# Rozelle Laneways

[Redevelopment of the Tigers Leagues Club Site]

Council Letter and AEP Report Design Response

**20170127-AR-DA010**

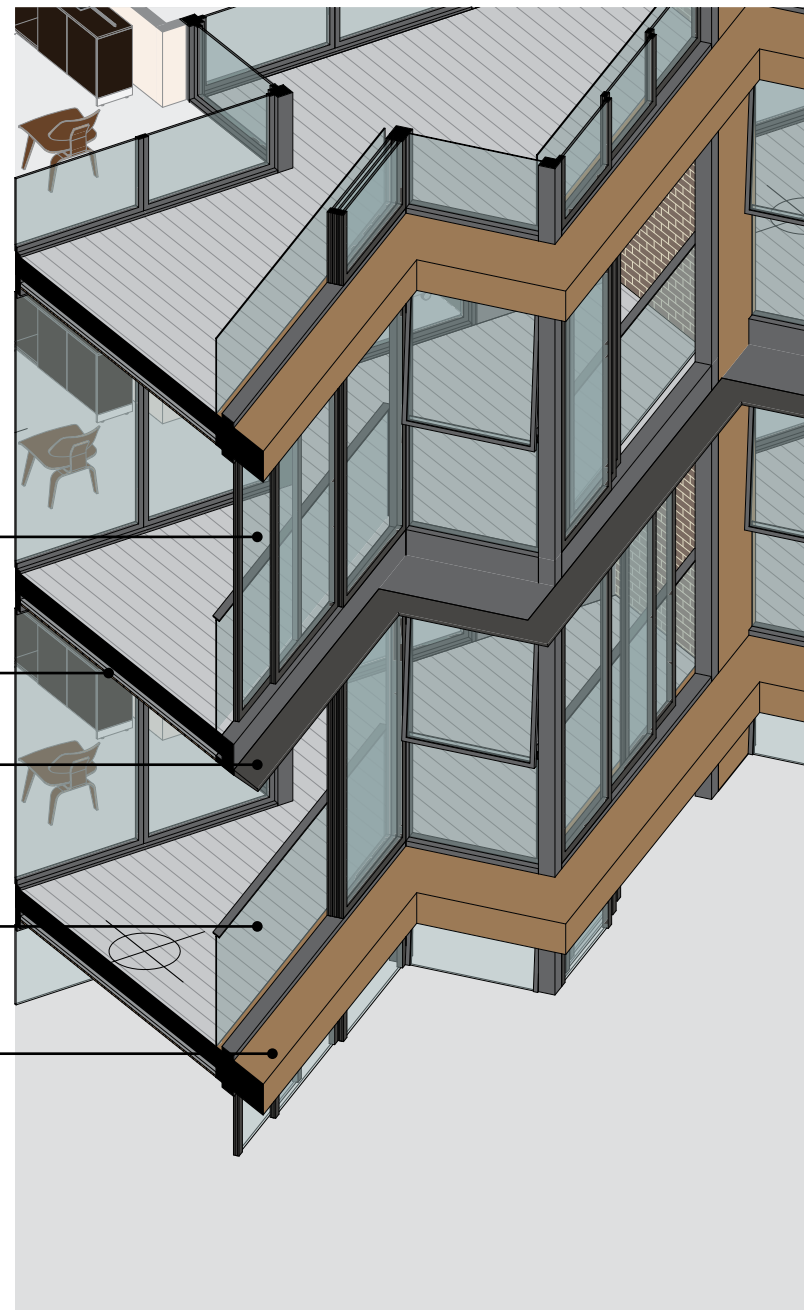
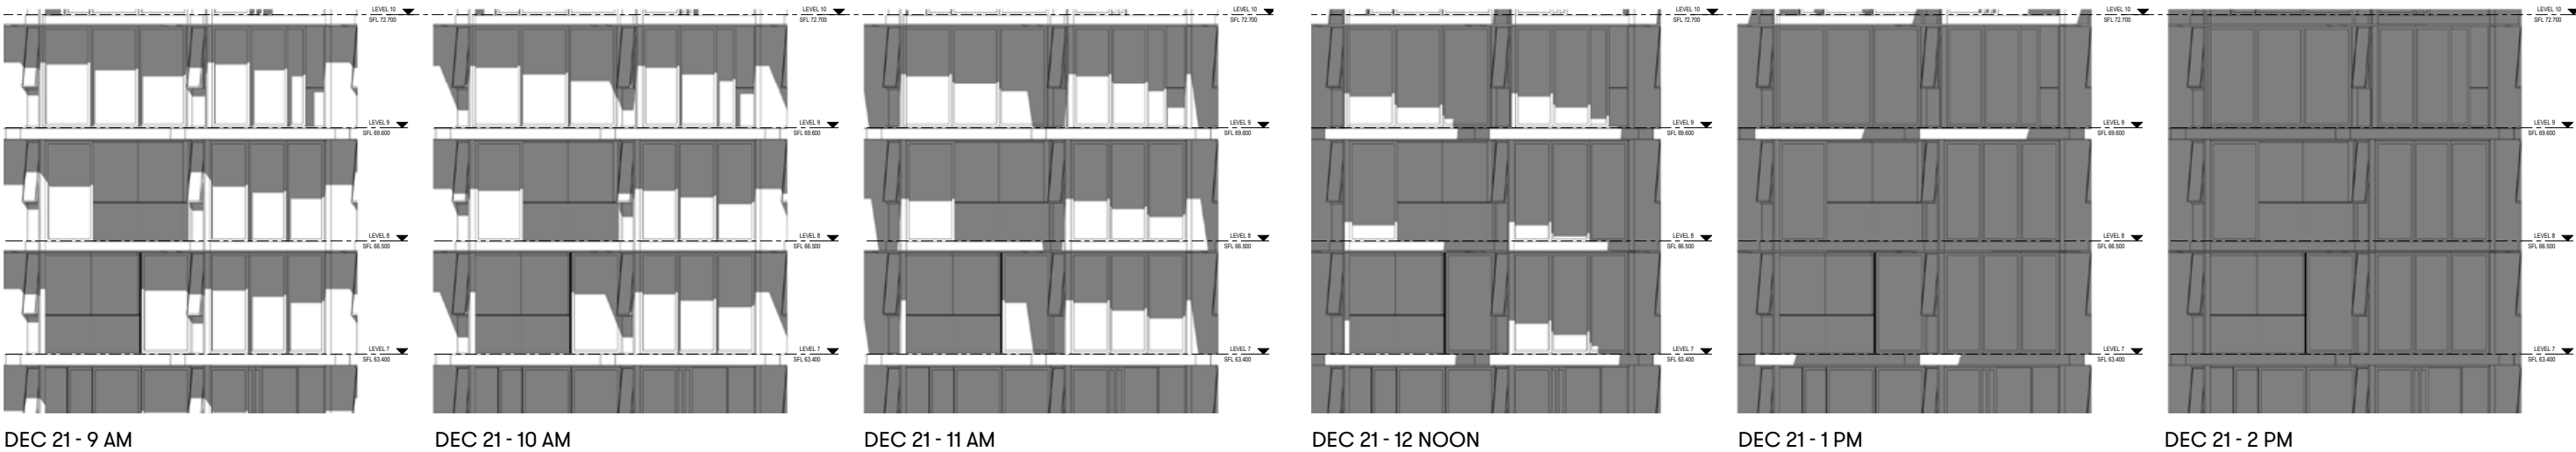
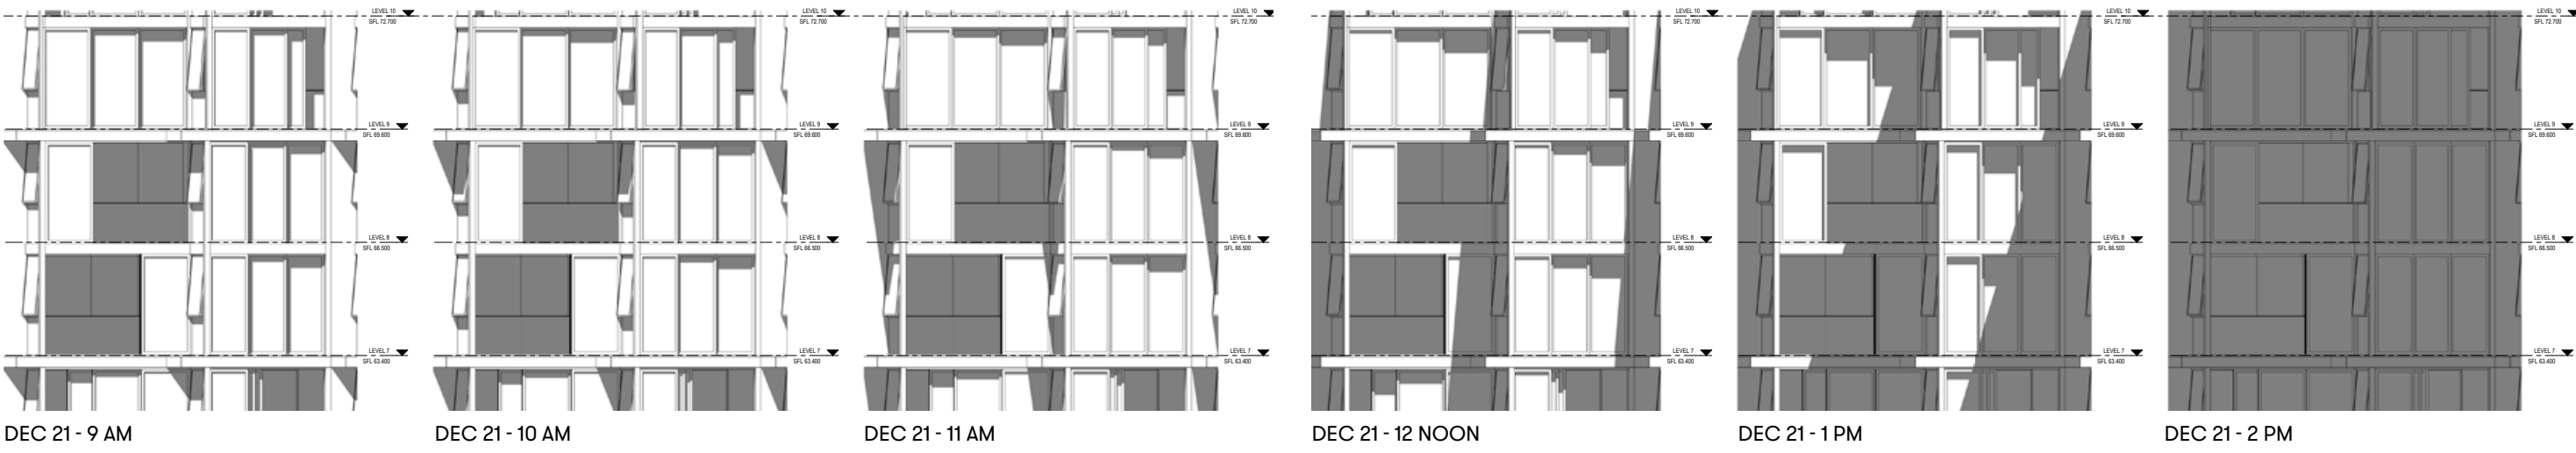
- c. **Recommendation 7:** The façade of the south eastern tower, Building A, would benefit from further design refinement aiming to break up the existing composition to introduce a stronger sense of the horizontal, and with an increased sense of depth to protect otherwise large extents of shear glass.

- d. **Recommendation 8:** The northern balconies covered by curtain walls should be further detailed to ensure they are well-ventilated and minimise heat loading - ideally through self-shading.

Reduced the glass area to the lower levels to improve privacy

Amended the configuration of solid panel and glass area in order to break down the extent of glass and reduce the sense of verticality and increase the sense of depth to the façade.

Provided sliding glass windows to northern balconies in order to improve natural ventilation

Added horizontal solar-shading in order to provide extra protection from unwanted heat gain in summer

Also, the horizontal solar-shading break up the composition of external glass screen and strengthen the zig-zag façade rhythm

### Section Scale 1:200

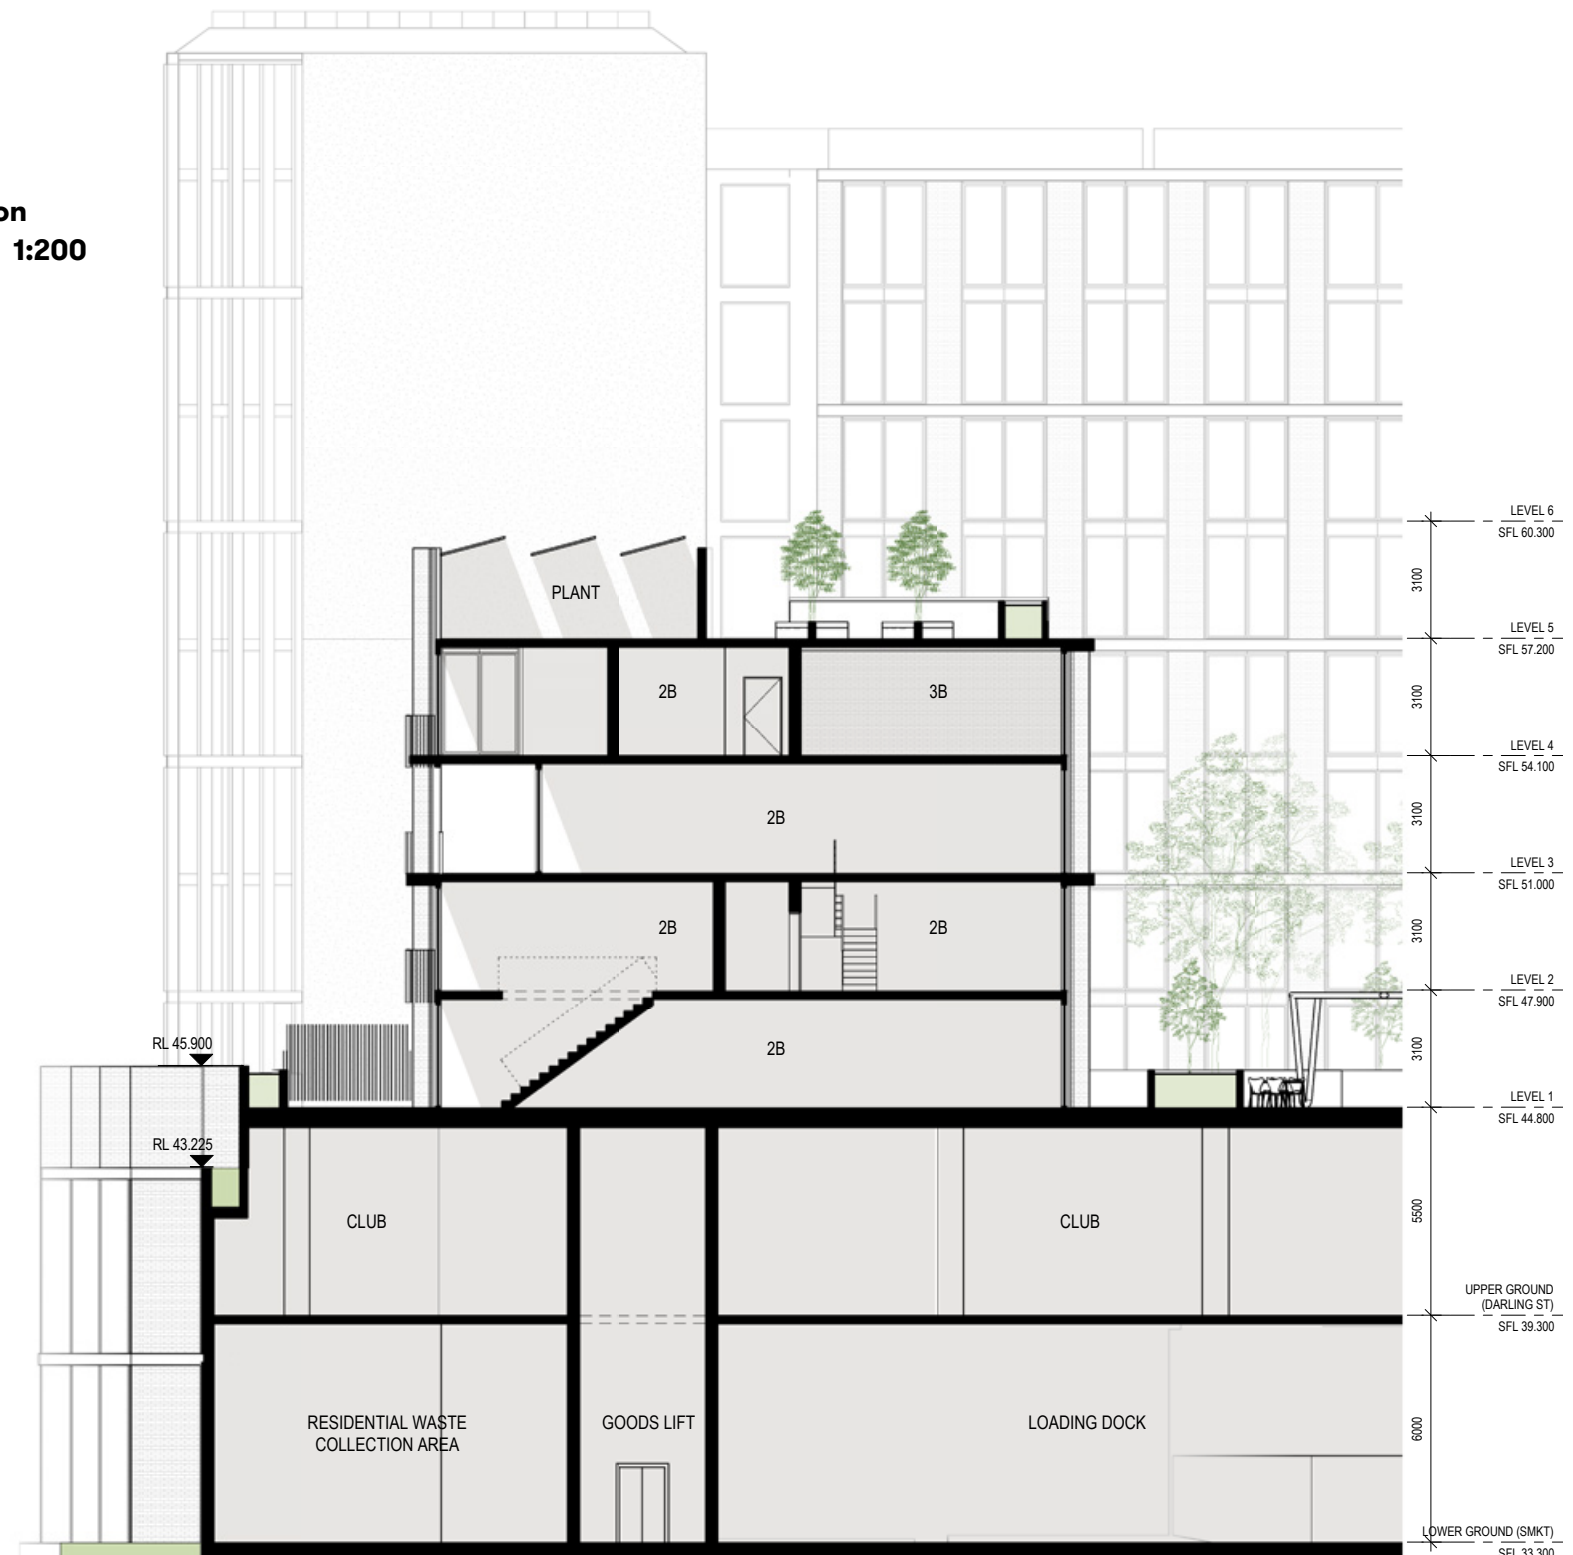
It is noted that the southern wing of residential building C creates a primary address to the north western boundary for Levels 1-4 provided with a 6m setback. The balconies of Level 1 entirely encroach the 6m building separation required by the ADG. An additional 3m setback should also be considered along both side boundaries as part of the ADG zone transition requirement (ADG 3F-1 and 3F-5) to improve residential amenity.

Building A has a 6m separation from the south eastern boundary. Apartments located within Levels 2-11 have habitable areas with primary address to the side boundary. It is noted that a greater setback (12m + 3m) is required under the ADG (ADG 3F-1 and 3F-5).

The side setbacks to the north west and south eastern boundaries are we consider, a result of prioritising the gross floor area towards the Victoria Road side of the site, in order to ensure the Waterloo Street side of the site is low scale in nature. This improves the relationship with the low scale residential of Waterloo Street. They also reflect the setbacks from the current DCP.

To the south east boundary, the lane condition in effect creates a street separation and with Darling Street belonging to a conservation zone it is considered unlikely for additional height and scale along Darling Street.

To the north west boundary, it is correct that the low (2 storey) terrace dwellings to the rear of Building C have terraces/private open space within the 6m setback zone. We have redesigned these terraces to:

- Lowered and setback the façade edge, between the reintroduced brick grid
- Introduced a landscaped zone;
- both of which creates a buffer between the terraces and the adjoining properties; that in turn prevents occupants of the dwellings stepping out to the edge

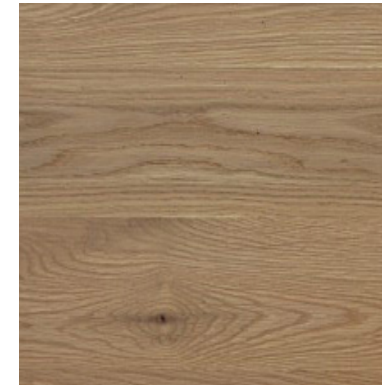
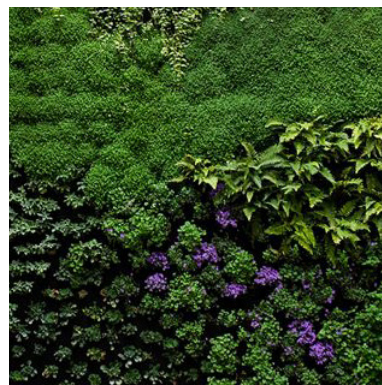
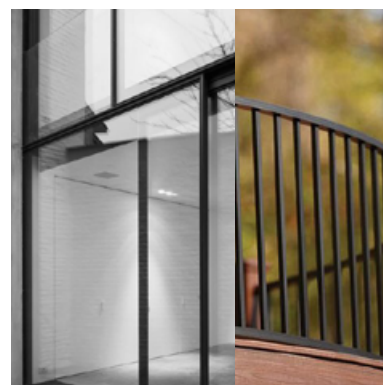
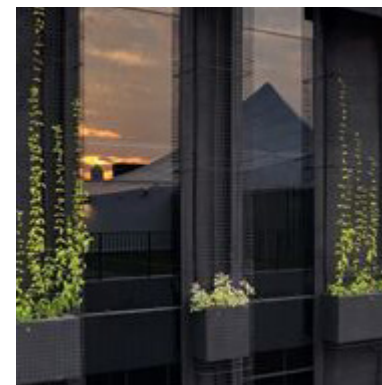
The drawings indicate the tower will be bronze in appearance, with bronze tinted glass and a “bronze look” in between with exposed concrete floors on the lower towers. Charcoal tint glass is proposed to the centre of the tower, on the Little Darling Lane elevation. This is inconsistent with Objective O2 of Section D1.16: Finishes and Materials of the DCP which states “To mitigate impacts to the surrounding HCA and heritage items, using appropriate materials and finishes”.

Materials, finishes, textures and colours should be similar and characteristic of the heritage items in the vicinity and within the HCA. The “bronze look” should be replaced with more sympathetic, muted, tones. The bronze and charcoal tinted glass should be replaced with clear glazing to complement glazing within the area.

Metal standing seam panels are proposed to the recessed components of the towers from Victoria Road. This material is not characteristic of the adjacent HCA and should be replaced with a more solid material. Cold brown masonry is proposed to the pediment level of the development to Victoria Road and Little Darling Lane. Clarification is required for this colour and where it is proposed to be applied. A beige colour would be more appropriate to complement the colours within the HCA.

- A range of face brick elements, reflecting the variety within the adjoining streetscape, that includes both face brick and masonry buildings; but also rendered and painted forms, in a variety of tones.

- Metal standing seams in the recessed sections of Victoria Road, seek to create a dark break between the forms; and reference the common iron roofs and more recent residential extensions of the area. This materiality is referenced in “The Valley C7” HCA Document by GML.

- The deep bronze toned panelling on the upper portions of a number of the buildings is considered commensurate with the area. Whilst bronze does not exist in existing buildings, it is a deep and muted tone albeit intended to change in tone as the light and sun passes across it.

- Glazing: We recognise the glazing is general a darker tone. However, this is a product of BASIX and core sustainability needs (and design commitments) around solar transmission. Clearer glass will either result in increased energy consumption or require a reduction of glass area; that we consider to be counter intuitive to what residents expect with regard to daylight within apartments.
- The ‘timber look’ material exists on balcony soffits, and has been clarified on the elevations, and shown in the CGI’s. The DA included a digital submission of the materials board in the design report, this has been revised on following page and included in the DA architecture set/
- We have however replaced the cold brown brick with a brown brick and removed the bronze tinted glass.

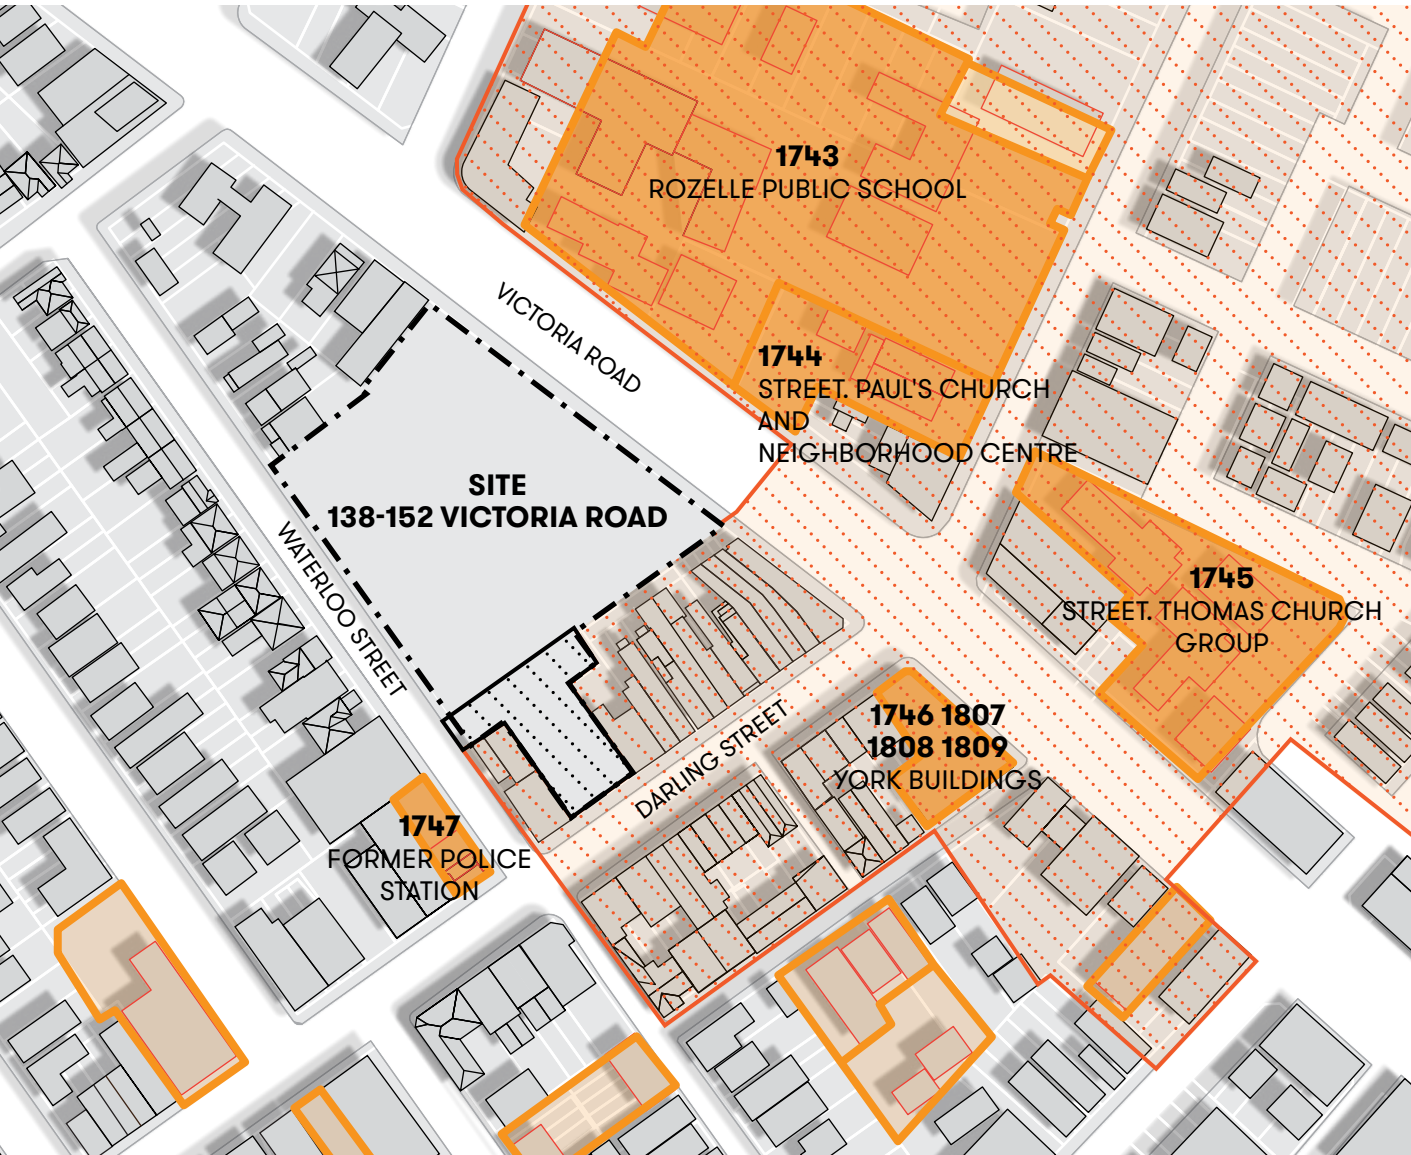
Control 3 in Section D.8: Visual Impact to HCA and Heritage Items requires that “before” and “after” perspective views from the heritage items, from Darling Street and from Waterloo Street are provided to assess the potential impact on heritage items and the HCA.

The “before” and “after” perspective views include Heritage View 2: Perspective view from York Buildings and Heritage View 3: Perspective view from Former Police Station. The accuracy of View 2 is questioned as the 2 storey podium level to Victoria Road is not shown in the photomontage. View 3 is not acceptable as it does not show the former Police Station building in its entirety. This does not enable a proper assessment of the visual analysis of the proposal in respect to the former Police Station. Revised perspectives for Views 2 and 3 must be provided that accurately depict the proposed development and include all of the former Police Station building in the photomontage
